NATIONAL DAM SAFETY PROGRAM. EDMONDSON DAM (INVENTORY NUMBER VA--ETC(U)

4. TITLE (and Subtitle) Phase I Inspection Report National Dam Safety Program Edmondson Dam Washington County		5. TYPE OF REPORT & PERIOD COVERED Final

PHASE I INSPECTION REPORT.
NATIONAL DAM SAFETY PROGRAM

Name of Dam: Edmondson Dam
State: Virginia
Location: Washington County
USGS Quad Sheet: Damascus, Va.
Stream: Middle Fork Holston River
Date of Inspection: 5 June 1980

PLATE I

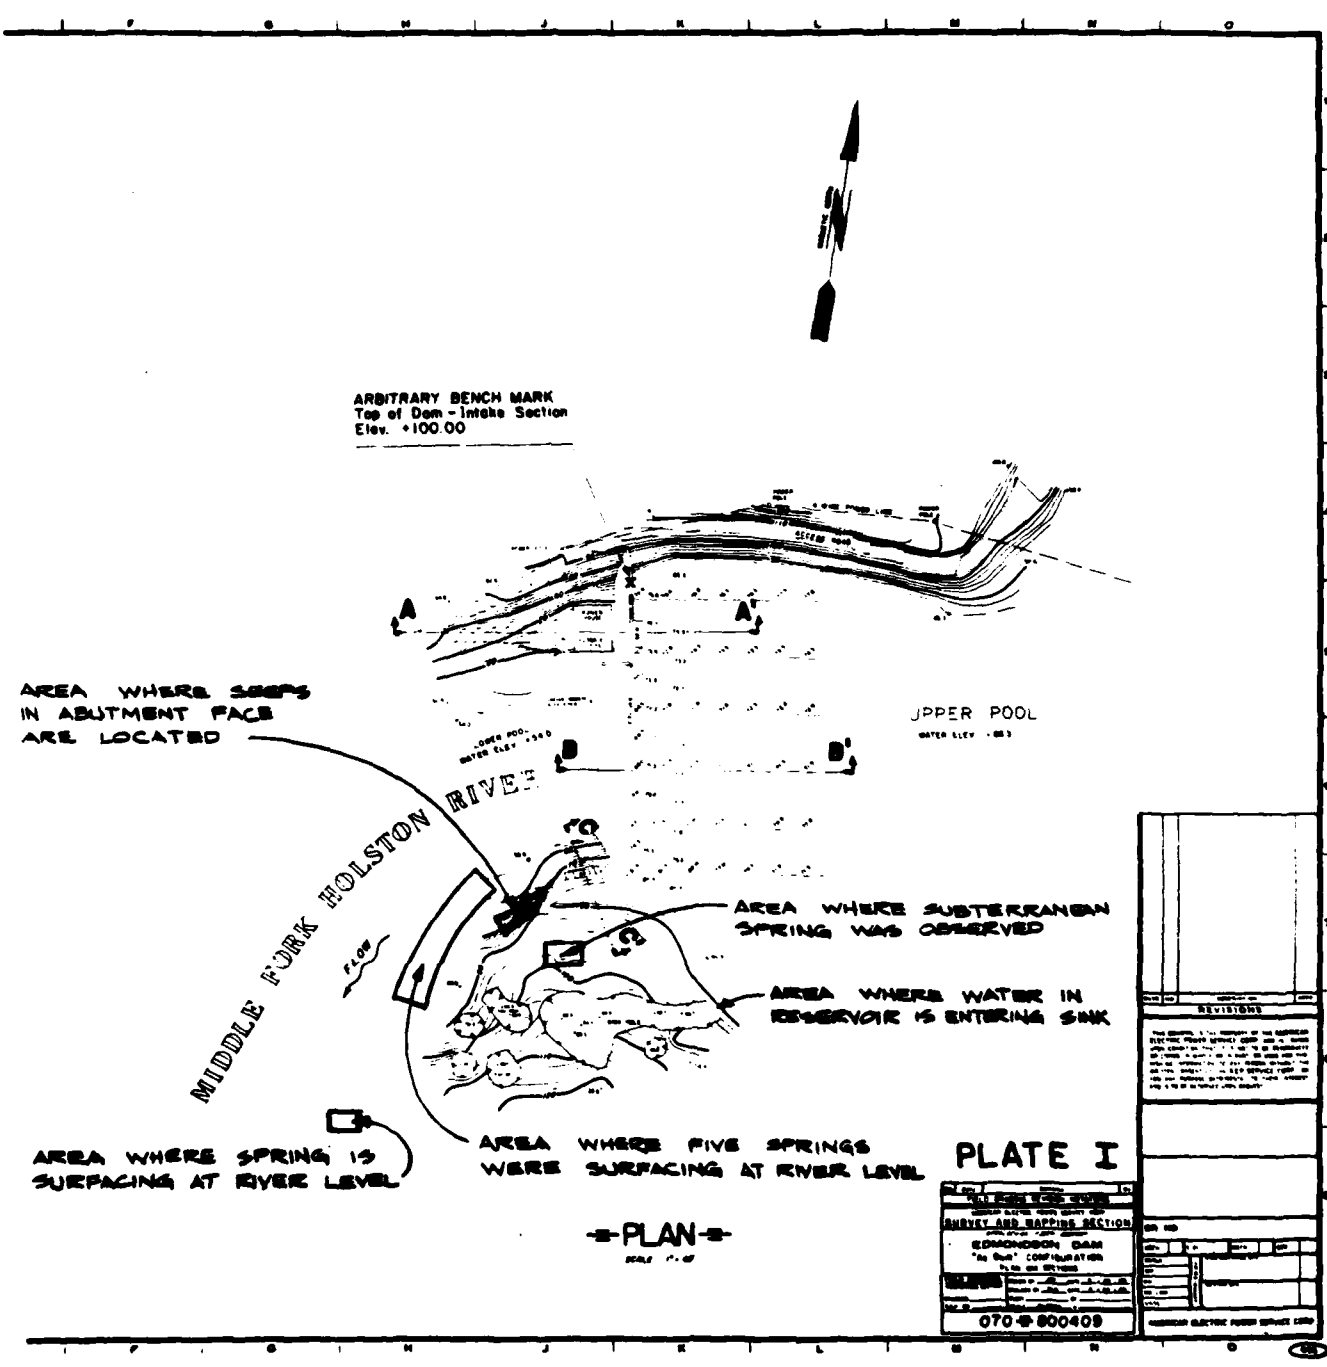
Inspection of the left abutment revealed numerous deep, apparently recent (Photo #7) sinkholes that have developed in the abutment. Approximately 9 sinkholes were sighted; the largest of these is about 200 feet long, 100 feet wide, and 25 feet deep. The series of sinkholes are aligned in a southwest direction so that they form a trough through the left abutment. The upstream end of the series of sinkholes is connected to the reservoir approximately 300 feet upstream of the dam. Flow visually estimated at 20 gallons per minute was observed entering the upper sinkhole. Located at the downstream end of the alignment of sinkholes is a subterranean spring surfacing at river level. Flow from the spring was visually estimated at 50 gallons per minute.

A smaller subterranean spring was observed on the crest of the abutment and is believed to be contributing flow to the numerous springs downstream of the dam. Several springs were observed downstream of the dam with flows estimated at 10 gallons per minute. Two clear flowing seeps (Photos #5 & 6) were found emerging from the open joints in the exposed limestone along the

downstream face of the abutment. Flow from the largest of these was estimated at 100 gallons per minute. Refer to plate I, Appendix I for location of sinkholes, subterranean springs, and seeps.

SECTION OF DAY	SECTION OF DAY
CORRISSON ELECTRIC CO.	CORRISSON ELECTRIC CO.
Sub. N° 1	Sub. N° 1
Ch. 1 - 1945	Ch. 1 - 1945

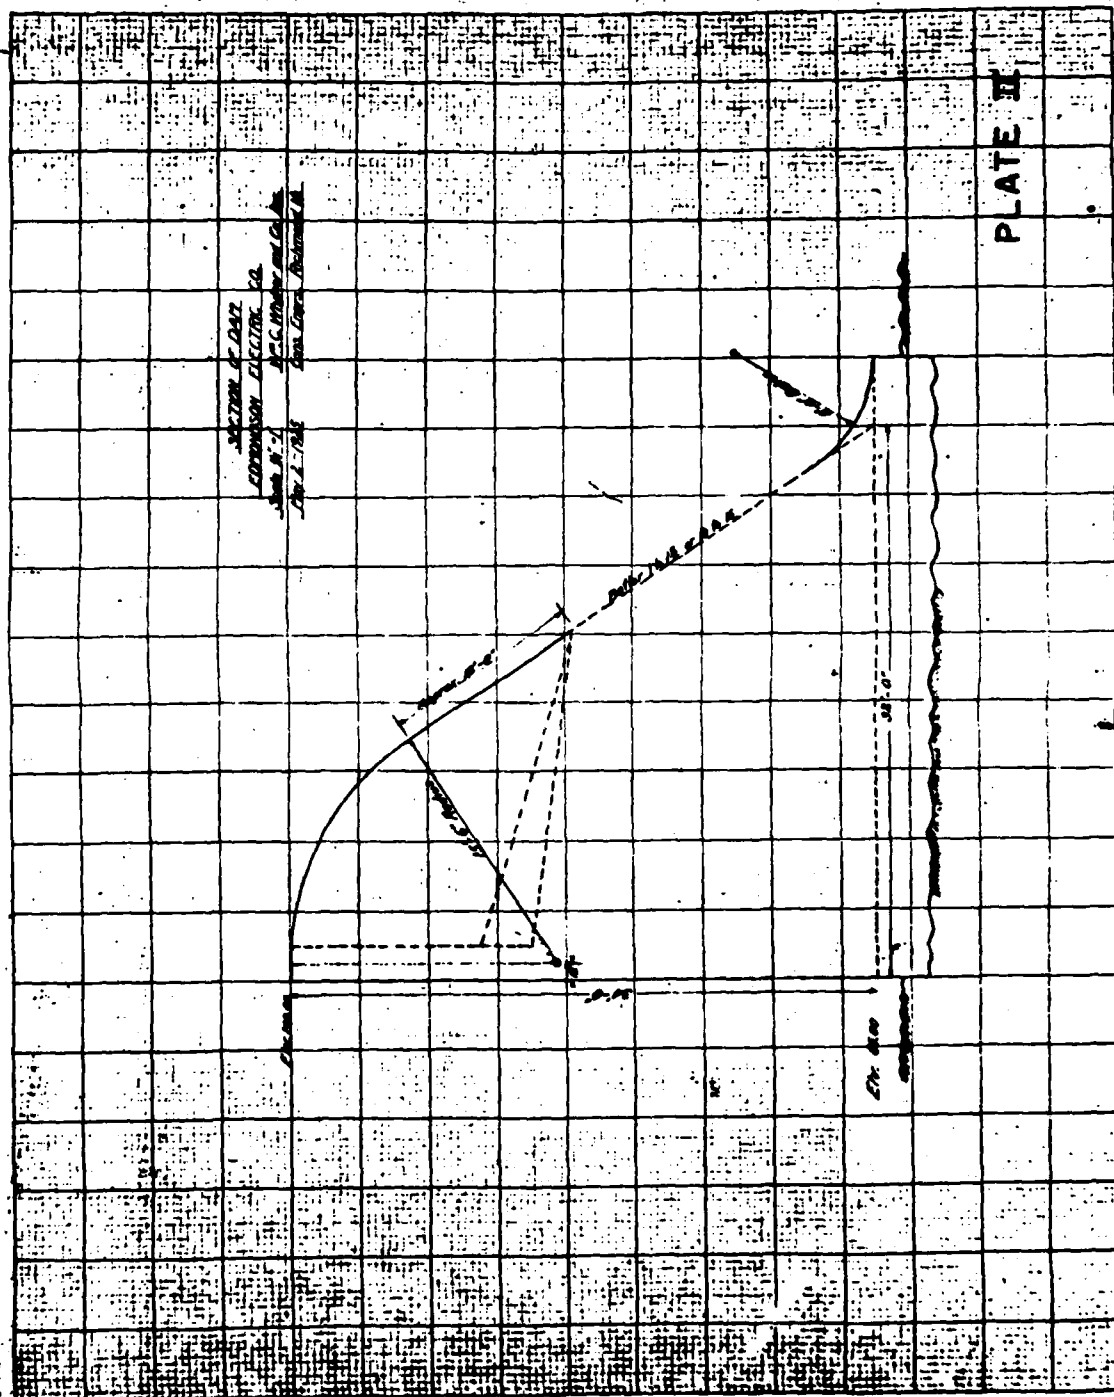
6.1 Stability Analysis: A preliminary stability analysis was performed based on a sketch by William C. Whitner & Co., Inc., Cons. Engineers, Richmond, Virginia, dated 2 May 1925. The sketch is titled "Section of Dam, Edmondson Electric Co." (see Plate II). The results of this analysis indicate that the dam is stable under normal conditions with reservoir level at the crest of the dam. When the spillway design flood is applied, however, the dam is on the verge of overturning failure with no margin of safety. Results of the stability analysis are summarized in Table 6.1. The spillway design flood, using present day criteria, is considered to be the 1/2 PMF for this structure (see Section 5.8). Since no original calculations are available, the basis of design is unknown.
